# **BARN GWMPASU:**

## Prosiect Ynni Gwynt Alltraeth Arfaethedig Mona

**Cyfeirnod yr Achos: EN010137**

Adopted by the Planning Inspectorate (on behalf of the Secretary of State) pursuant to Regulation 10 of The Infrastructure Planning (Environmental Impact Assessment) Regulations 2017

Figure 11.2.3 Position and geographical area of herring closures within the Irish Sea as defined by Council Regulation (EC) No 850/98, amended by EC 2723/1999.

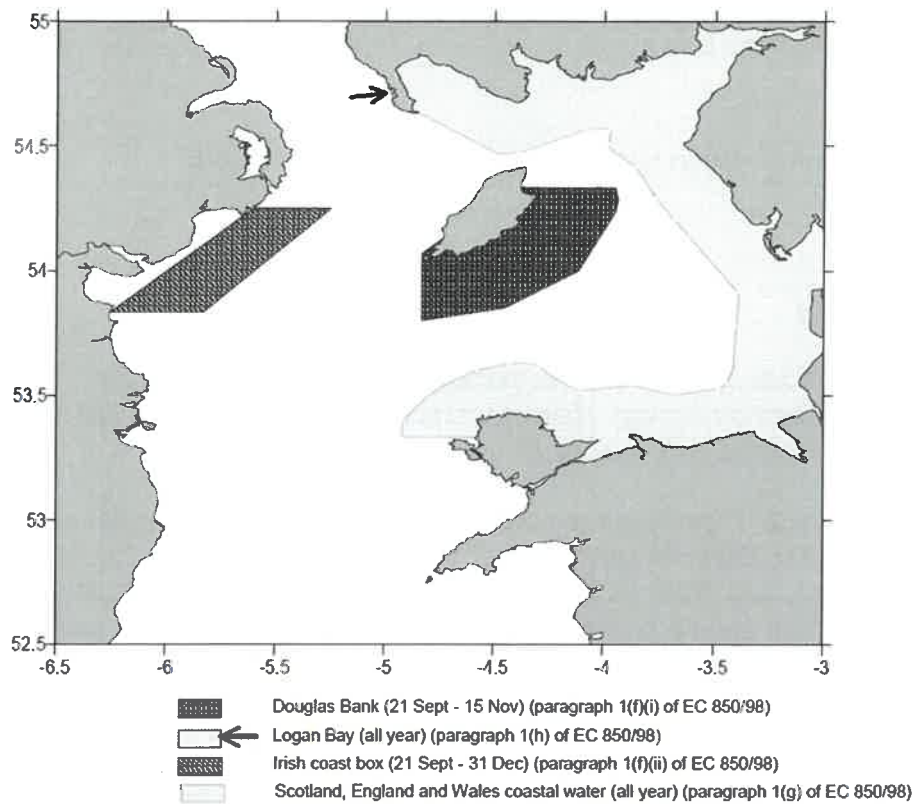
- Also please note the statutory herring spawning closure in Manx waters in relation to sections **4.2.4.19 – 21**. This was originally included within EU Council Regulations (EC) No 850/98 (amended by EC 2723/1999, and has since been rescinded. However, the closure remains in place within Manx law : [https://www.gov.im/media/1364592/sea-fisheriestechnicalmeasuresbye-laws2000\\_7.pdf](https://www.gov.im/media/1364592/sea-fisheriestechnicalmeasuresbye-laws2000_7.pdf) (byelaw 18).

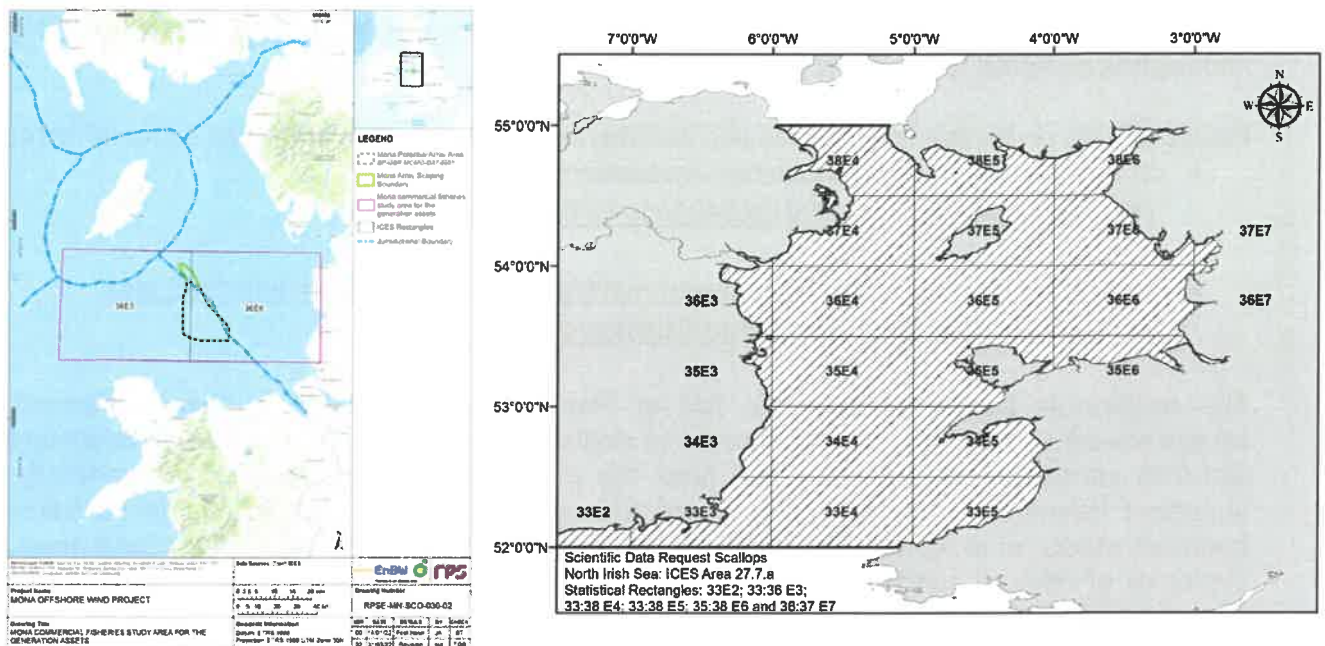
Temporal and spatial fisheries closed areas are also present in Manx waters, and their positions may vary depending on annual stock assessment surveys. The latest versions may be found on the DEFA fisheries website<sup>13</sup> (under commercial fishing licence conditions), but may change from year to year.
